CUI DEVICES

Product Change Notice (PCN)

PCN Number: PCN-0370542-01

CMT-8504-100-SMT-TR

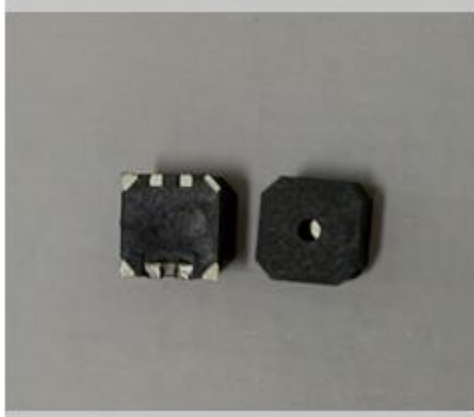
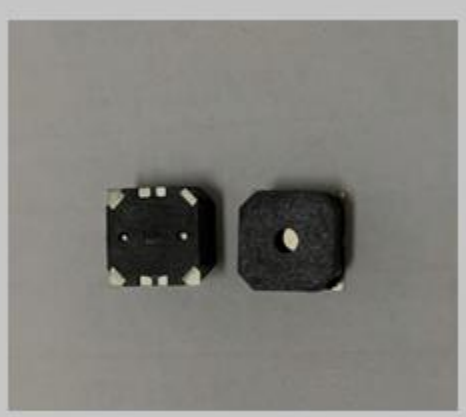
Improving the structure by changing the bottom to integrated with injection molding, and the connection parts being put inside. The item will now be done by machine to increase the capacity of production.

The only change is the injection Molding. This does not change any of the Characteristics of the product.
